## **RECCOMENDATION TO THE DESIGN REVIEW COMMITTEE**

**File No.** Z0281-21-D

**Proposal:** Development of the site with a new Memory Care Facility with 55 beds.

**Site Address:** 7910 SE Johnson Creek Boulevard

## Site Plan

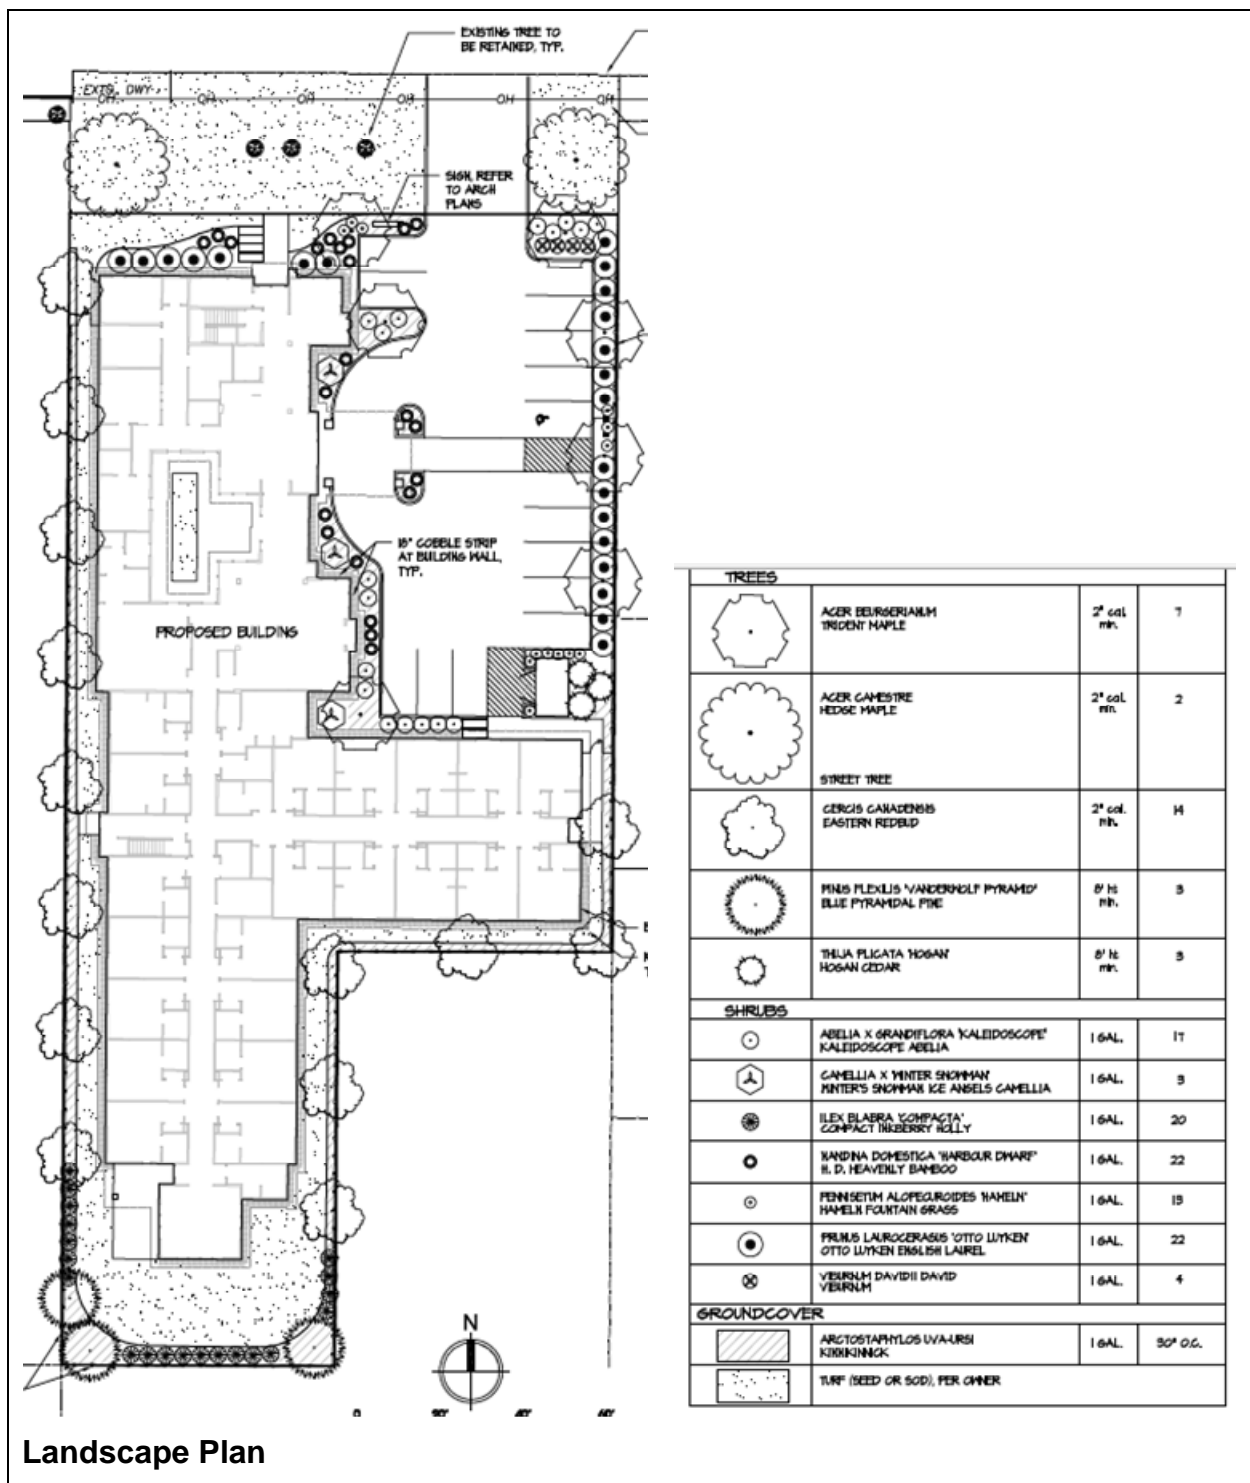
- 2) **Prior to issuance of building permit, the applicant/property owner shall complete the following:**
  - a) Provide an updated site plan showing a total of 7 bicycle parking spaces, per ZDO Table 1015-2.

- b) Provide an updated site plan showing a loading zone, per ZDO Table 1015-3.
  - c) Trash and recycling enclosure shall fully address the standards of ZDO 1021. Applicant shall coordinate with Clackamas County Sustainability to ensure compliance with the standards of ZDO 1021.

requirements for 1 bicycle spots per 8 beds. The design indicates 4 bicycle parking spaces. An additional 3 bicycle parking spots will be required. Table 1015-3 provides standards for loading zones. Nursing homes of over 25 beds require one loading zone of not less 35 feet by 12 feet, with 14 feet of clearance. No such parking spot is shown on the site plan. The additional bike parking and loading zone will be required as a condition of approval. **As conditioned, these standards are met.**

***Finding:*** The trash and recycling enclosure is shown on the submitted drawings. Though it is unclear that the proposed enclosure/facility is sufficient to adequately service the proposed uses, there is adequate space on the property to establish suitable services. **As conditioned, these standards can be met.**
